Town of Kittery
Planning Board Meeting
September 8, 2016

412 Haley Road – Sketch Plan Review

Action: Review application. Approve or deny sketch plan. Owner Marilyn Mann & James Smith and Applicant, Green & Company, requests consideration of a 12-lot subdivision located at 412 Haley Road (Tax Map 34 Lot 3) in the Residential – Rural (R-RL) and Shoreland Overlay (SH-OZ-250') Zones. Agent is Joseph Coronati, Jones and Beach Engineers, Inc.

DRAWING No.
C4
SHEET 4 OF 6
JBE PROJECT NO. 16030

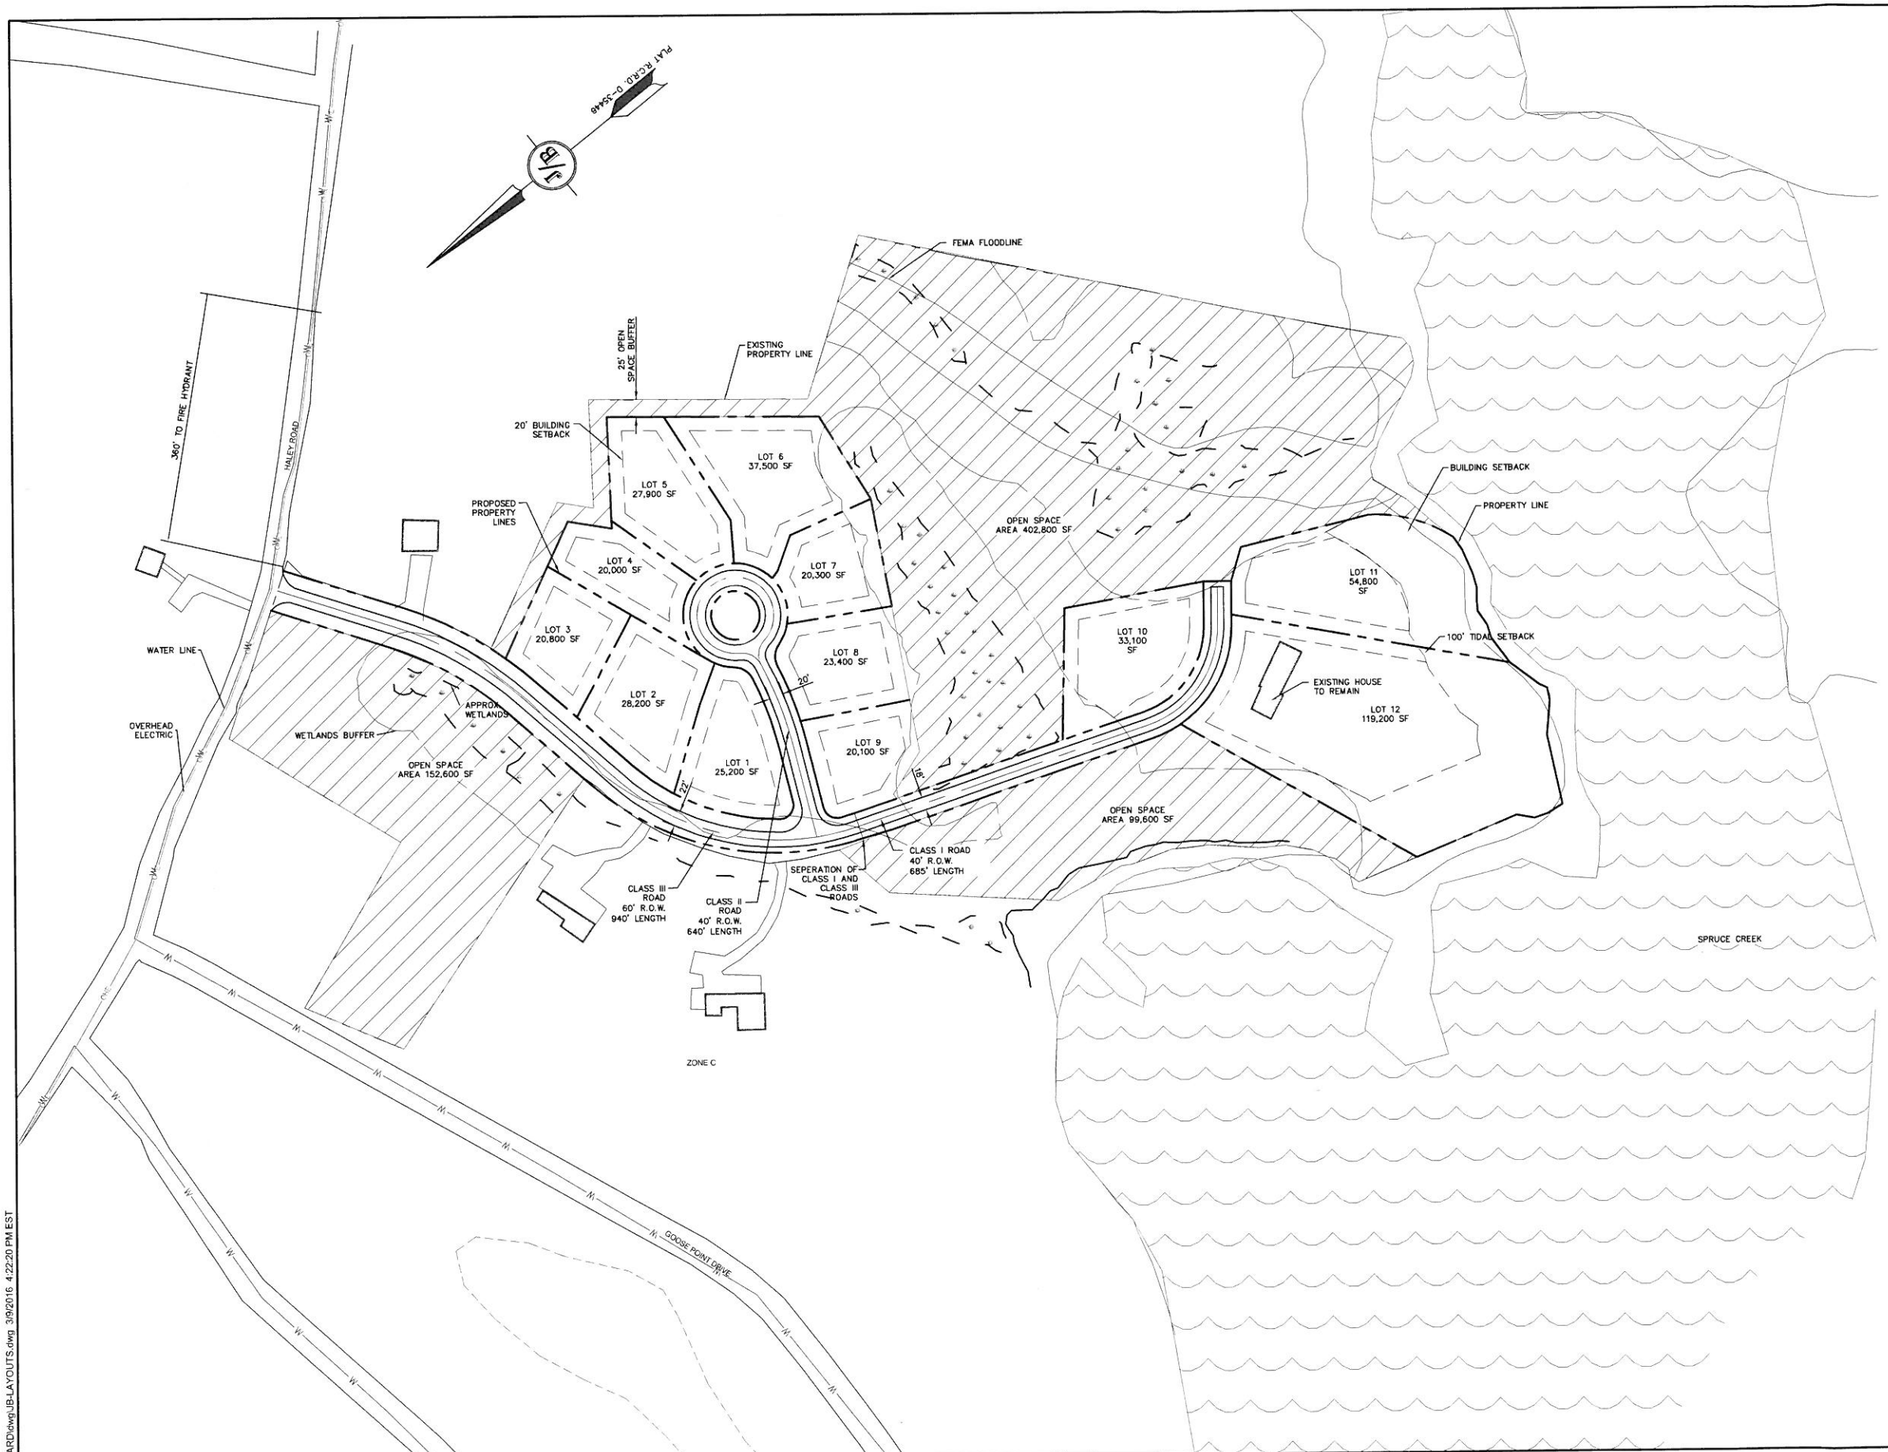
3. *In the July 20 cover letter, the applicant states the minimum land area per dwelling unit for the R-RL zone is 20,000 square feet. The minimum land area per dwelling unit in the R-RL zone is actually 40,000 square feet. However, this may have been a typo in the cover letter, as it appears the applicant used the correct minimum land area per dwelling unit in determining the net residential density of 14 lots. (13.6*43,560/40,000 = 14.8).*

5. *The applicant proposes improving the existing gravel driveway to provide access to the subdivision. A class 3 private street will provide frontage for lots 1, 2, 6, 9, 10, 11, as well as the two existing lots, identified as 402 and 404 Haley Road. A second Class 2 private street will access lots 3 – 7. The two streets will require different names and the applicant will be responsible for any improvements to conform to the street standards as outlined in Table 1 of Chapter 16.8, Article IV. Since the original street ROW was never names, properties identified as 402 & 404 Haley Road will likely need to change their addresses.*

8. *No buffering is provided along the cluster development and abutting properties 424 and 428 Haley Road, located to the east of the proposed development. The Board may want to consider requiring a buffer to preserve the character of abutting properties. This would result in a somewhat reduced building envelope for lots 1, 3, 4 and 5.*

9. *The two waterfront lots begin at the cul-de-sac, extend approximately 500', and expand out to show a building envelope, creating two flag-shaped lots. Flag shaped lots are prohibited per Title 16.8.16.2. In addition, this design provides approximately 25' of frontage for both lots 10 and 11. The applicant may want to consider extending the ROW to end in a cul-de-sac closer to the buildable area of lots 10 and 11, thus resulting in lot shapes consistent with the dimensions outlined in Title 16.8.16.2, Lot Shape. This may also help to ensure the driveway(s) are less than the 500-foot limit.*

11. *The location of subsurface wastewater disposal systems and reserve areas are not depicted on the sketch plan. Proposed sites should be included on preliminary and final plans.*

13. *The required open space is divided into three segments: directly to the north of the ROW upon entering the property from Haley Road; on the easterly edge of lot 10; and on the westerly edge of lot 11. Per Title 16.8.11.6.E.6, when possible, open space should be in a contiguous form of unfragmented land. The Board may want to consider if an alternative arrangement of the required contiguous, unfragmented open space exists.*

15. *The sketch plan incorrectly identifies the name of the road "Goose Point" as "Goose Pond Drive" and should be revised.*

RIGHT OF WAY PLAN FOR MARILYN MANN OFF HALEY ROAD KITTERY, MAINE

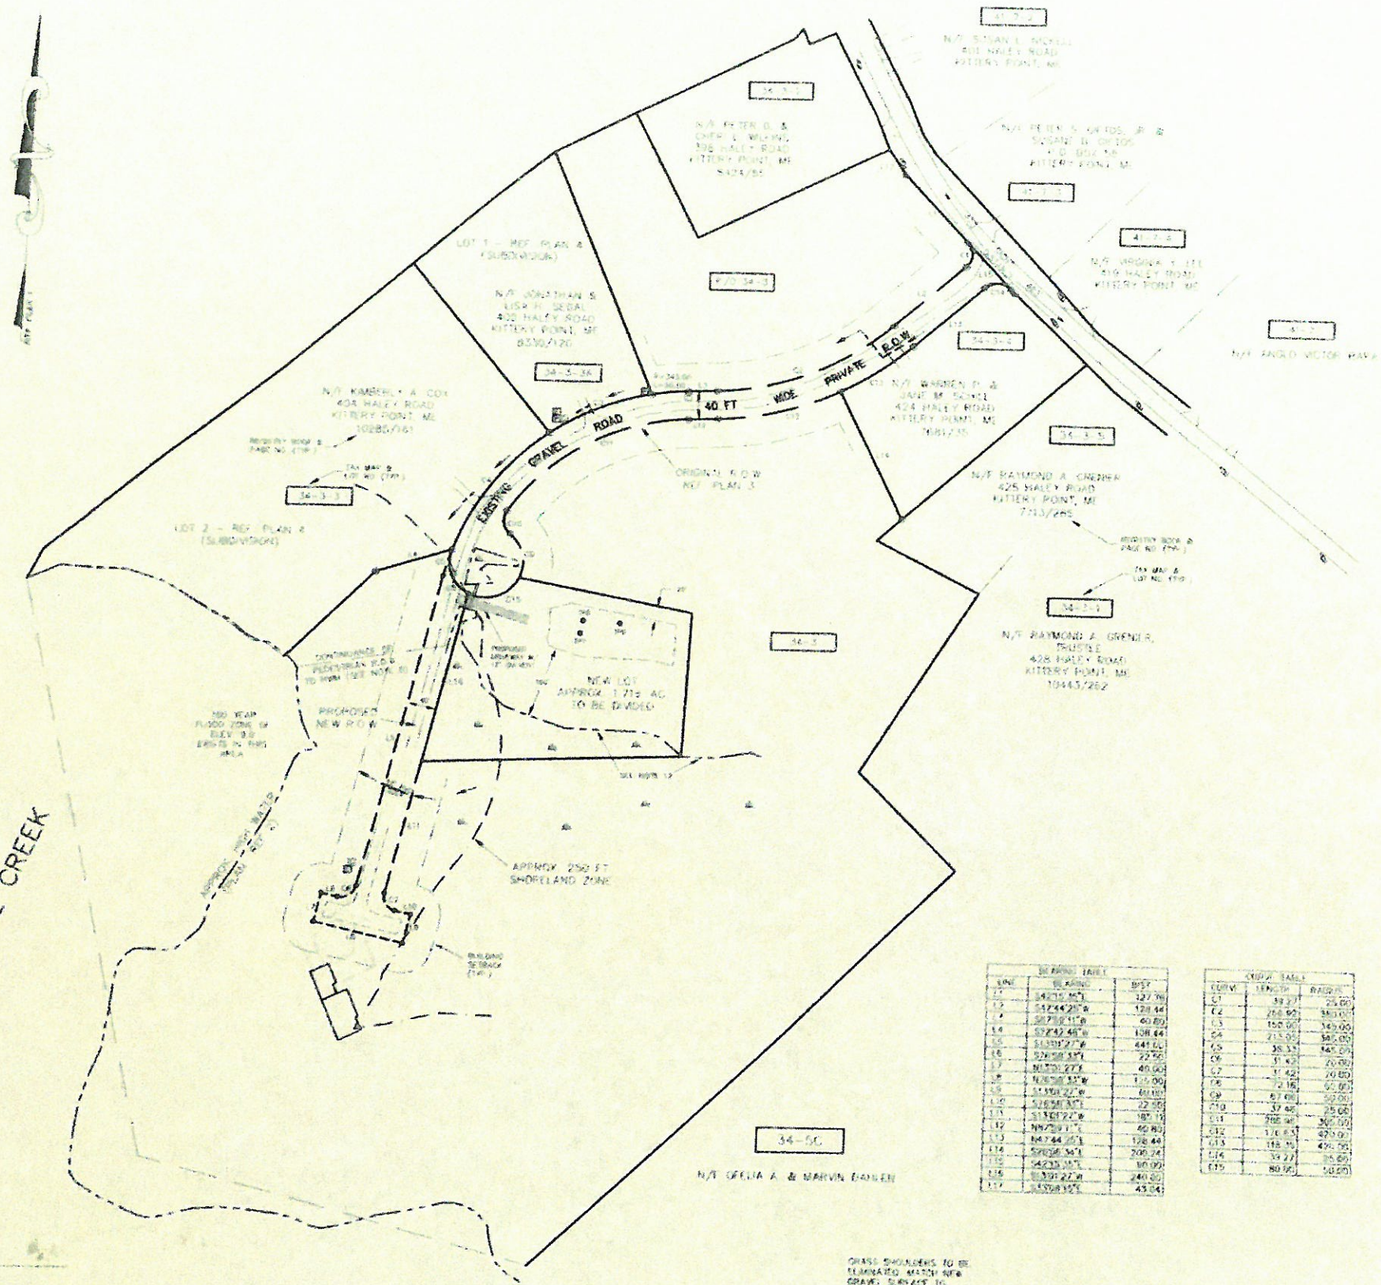
7. *As stated on the ROW plan dated 10/29/2001, and revised 6/30/2004, existing underground utilities are located under the northerly and westerly shoulder of the gravel drive. The applicant proposes to extend the waterline into the subdivision, as well as install hydrants along both roads.*

17. The Right-of-Way (ROW) was originally approved by he Planning Board 11-09-1995. An amendment to extend the ROW to provide frontage for a proposed new lot was approved on 12-13-2001 (copy of approved plan attached). Questions have arisen regarding the following plan notes from the 2001 amended plan:
    a. Plan note 7 - No more than five dwelling units can use the right of way with the gravel road improved to 16-foot wide; one dwelling unit on each of the following lots: 3, 3-4, 3-3, 3-3A and the new lot.
    b. Plan note 13 - The right of way will remain privately owned and maintained by the land owners. The road will not become a "town road".

These plan notes appear to be a result of deliberations during the approval process for the 1995 ROW application. Minutes of the 11/9/1995 Planning Board meeting reflect a discussion regarding waivers to street standards. The proposed ROW was longer than what was permitted at the existing 12-foot width. The Board discussed plan note restricting use of the ROW to no more than four dwelling units "at its existing 12' width" in an attempt to avoid the addition of lots on a narrow street. The 2001 amendment permitted up to five dwelling units, with consideration of a width increase from 12' to 16'.

These restrictions are recommendations made by previous Planning Boards, specific to the application review at the time. These restrictions may be modified, pending approval by the current Board. No covenants or restrictions appear to be associated with the property's deed that limit the number of units allowed or condition of the ROW. The current application is proposing to improve

Note #13 on this plan states that, "the road <u>will</u> <u>not</u> become a "Town Road" "

It also says that no more than five dwelling units can use the right of way (note #7).

This means that 15 years ago, the Town agreed to ONE MORE HOME on our road, and that it WOULD NOT become a town road. How is this proposal possible with documents like this in hand and on record?
